Item Name: Aft Crosstube - High 407

Reference: REWORK PER ECN 15-557

DRAWN	RF		
CHECKED	9P	DRAWING NO.	REV. G
MFG. APPR.	9P	D407-667-245	SHEET 1 OF 4
APPROVED	9P	TITLE	SCALE
DE APPR.	9P	CROSSTUBE ASSY (407 HIGH AFT)	NTS
DATE	15.03.20	COPYRIGHT © 2002 BY DART AEROSPACE LTD THIS DOCUMENT IS PRIVATE AND CONFIDENTIAL AND IS SUPPLIED ON THE EXPRESS CONDITION THAT IT IS NOT TO BE USED FOR ANY PURPOSE OR COPIED OR COMMUNICATED TO ANY OTHER PERSON WITHOUT WRITTEN PERMISSION FROM DART AEROSPACE LTD.

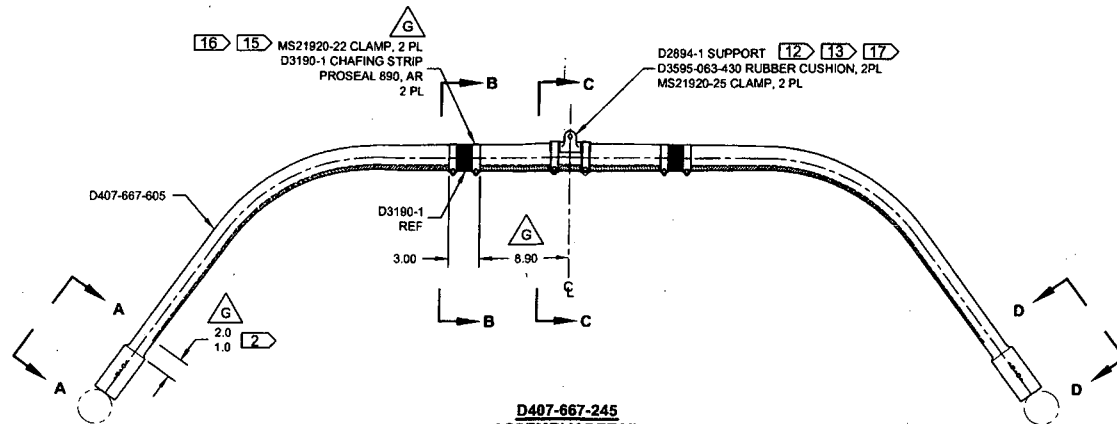
G	INCORP. DEO'S D407-667-245-F1/F2 (ZN D8-1, A8-1, D5-2, B6-2, C6-2); 8.90 WAS 8.53 (ZN D5-2); TORQUE REDUCED FOR CHAFING SHIELD (ZN A8-1); FINISH REVISED TO ALLOW MANUFAC. FLEXIBILITY (ZN C8-1)	RF	15.03.20
F	REFORMAT NOTES TO NEW STANDARDS (ZN B8-1); RELOCATED FLAG #6 (ZN A8-3) PER NCR 210; REMOVED REF. & ADD TOLERANCES (ZN C6-3, C4-3 & D2-3)	RF	08.11.06
E	8.02 AND 8.53 WERE 8.40 AND 8.90 (ZN D5-2); REORGANIZED VIEWS AND REFORMATED DRAWING TO CURRENT STANDARDS. REASONS: CLAMPS MOVED 0.375 TOWARD CL TO ELIMINATE INTERFERENCE WITH AIRCRAFT MOUNTS. REFERENCE: PAR#08-21 AND ECN#1225	MB	08.07.24
D	ADD VIEW FOR OEM SKID HOLES, ROTATE ORIENTATION OF CLAMPS SECTION F-F. REMOVE .851 ABRASION STRIP, ADD MAGNOBOND 6398, ADD CUSHION	PH	07.02.07
C	ADD HOLES AND NUT PLATES FOR COMPATIBILITY WITH BHT/AA SKIDTUBES	PH	05.07.28
B	ADD CHAFING SHIELD	CP	03.05.21
A	NEW ISSUE	CP	02.05.13
REV.	DESCRIPTION	BY	DATE
DESIGN	9P	DART AEROSPACE LTD HAWKESBURY, ONTARIO, CANADA

NEEDS TO BE REWORKED PER ECN 15-557

REMOVE CHAFFING SHIELDS AND CLAMPS (MS21920-22)
AND SCRAP

Paint B#132024
REPLACE WITH NEW PER NEW DRAWING REV G

1- Install chafing shield as per D407-667-245 using DT10096 to establish 8.90
dimension. Top holes should be facing up.

****Ensure chaffing is to be position "overlap" AFT****
